# PRODUCT INFORMATION UPDATE

## VAL-CO Updates Rooster Pan Grill Spacing for Improved Animal Welfare

### Rooster Feeder Grills

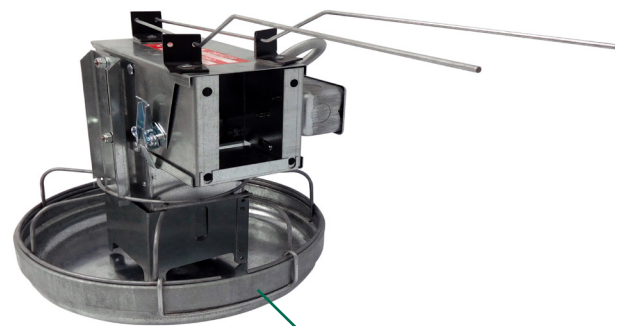
VAL-CO has recently increased the Rooster Pan Feeder grill spacing. The new grill now has 7 wires (reduced from 12) with a wire diameter of .179”.

Grill clips have also been updated.

*Fewer spokes for better access.*

*Updated clip for simple maintenance.*

PN 450950 for End Control Pan; 450957 for Mid-line Control Pan.
